X3T9.2/90-199

December 10, 1990

I'd like to offer a solution to a problem that is occurring with the 4-circuit power connector shown in Figure 13:J3/P3 Power Connector of the Enhanced Small Device Interface Standard. This figure shows no internal dimensions of the connector which are critical to assure industry intermateability. Although this has been generally regarded as "an .084 connector system", referring to the diameter of the pin, our customers are seeing product from various suppliers ranging from .083 down to .079 diameter. The mating cable connector cannot provide satisfactory long term stable contact resistance and acceptable mating and unmating forces over this pin diameter range.

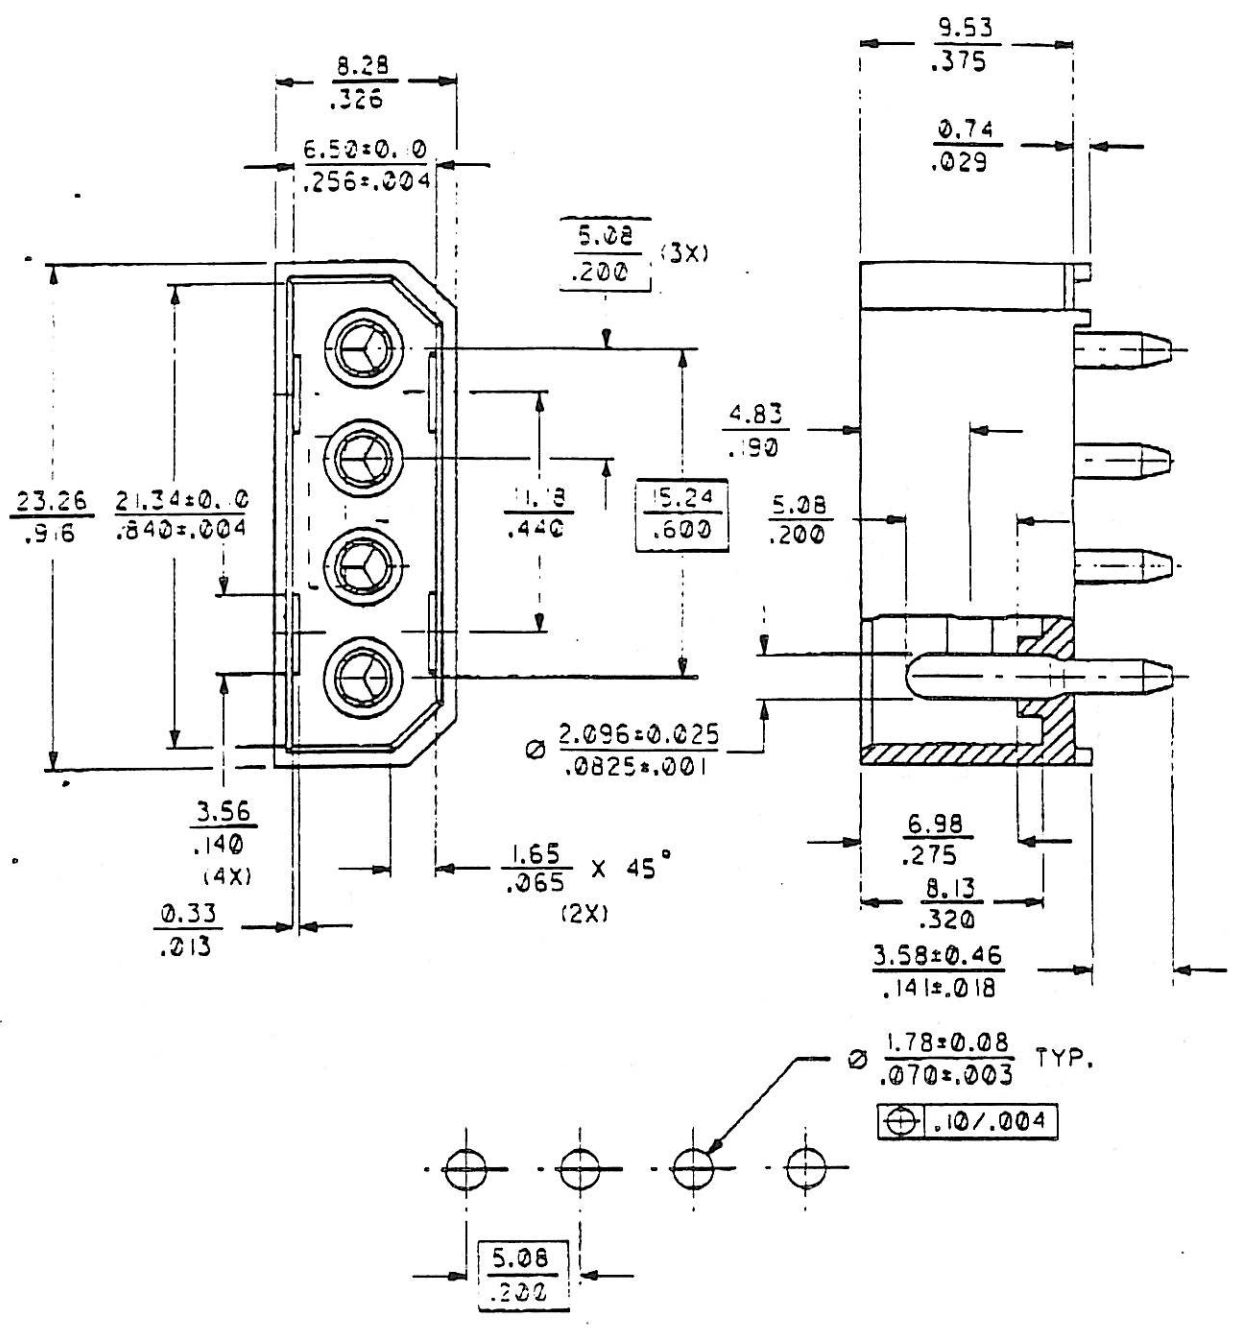
I would like to make the following proposals. First, I'd like the ESDI committee to agree to add internal mating dimensions for the J3/P3 connectors or, as an alternative, issue a technical advisory document detailing the required mating dimensions. Second, I have enclosed for committee review a dimensional proposal from Molex which reflects the dimensions Molex feels will resolve intermateability issues and allow all vendors to make intermateable products.
